GOVERNMENT OF THE DISTRICT OF COLUMBIA
DEPARTMENT OF TRANSPORTATION

MEMORANDUM

SUBJECT: ZC Case No. 16-09 – 1200 3rd Street NE - Central Armature Works

Figure 1 Site Design and Access (Source: Grove/Slade CTR 10/14/16 Fig. 6)

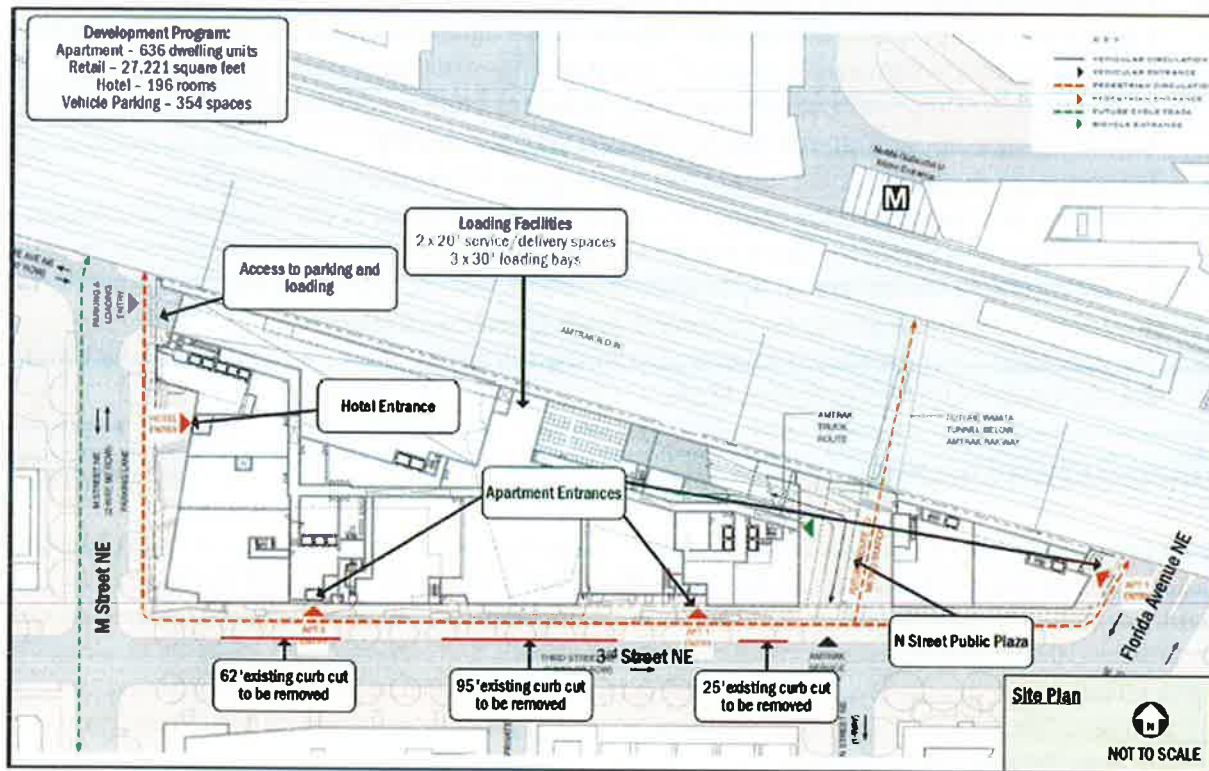
- Building projections shown on Florida Avenue NE do not meet building code for separation between the curb and property lines and should be removed;
- Steps shown on M Street NE should be moved out of the public space; and

The Applicant's drawings show stairs or steps within the public space along M Street NE. These should be shifted north outside of public space. The Applicant's drawings also show building projections close to the Florida Avenue curb lines. Per DCMR 3202.7.1.1., there needs to be a minimum of 15-foot separation between the curb and the projection.
